Enclosure 3 – RAI Response

RAI Letter Dated July 6, 2015

NRC QUESTION:

Figure 4-1 Document Relationship through Current Lifecycle Phase (OPRM)

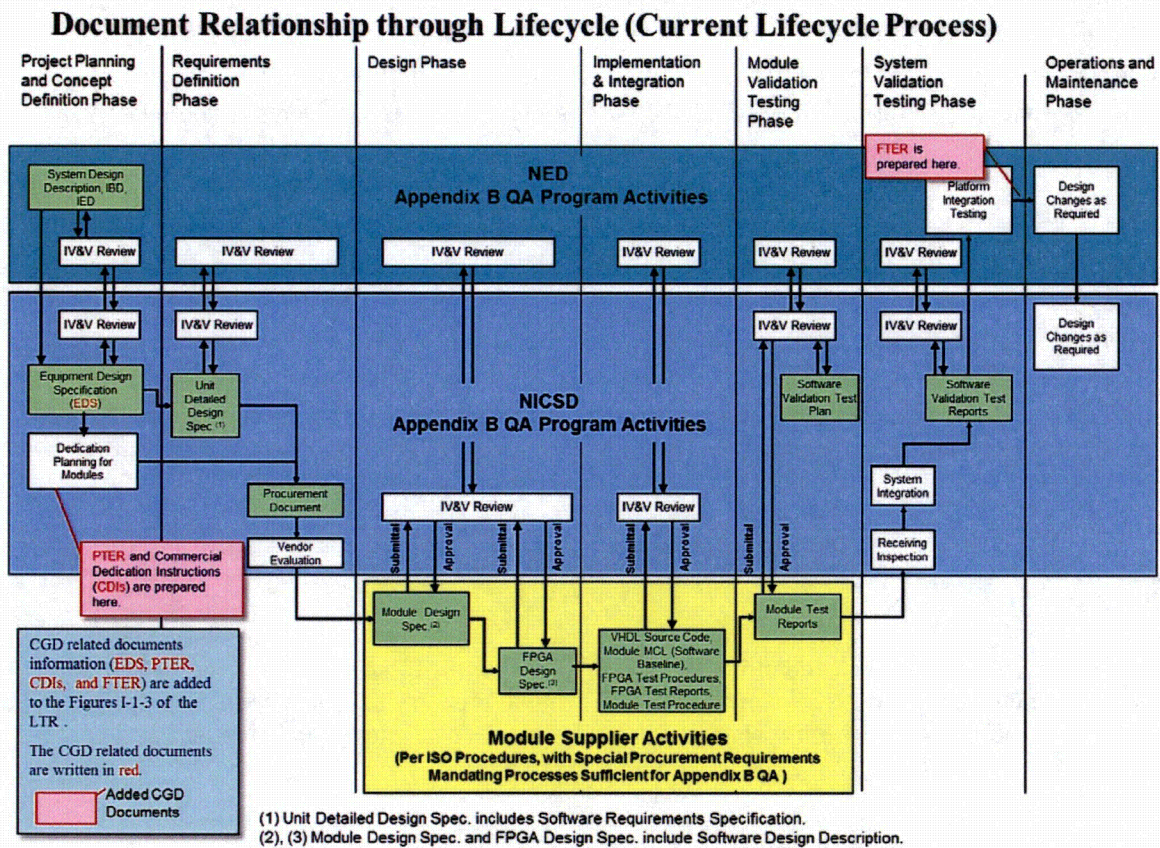
4. Please provide figures illustrating the relationship between the different design documents and the system lifecycle for the PRM system and the OPRM unit.

The following figures illustrate the relationship between the different design documents and the system lifecycle for the PRM system and the OPRM unit.
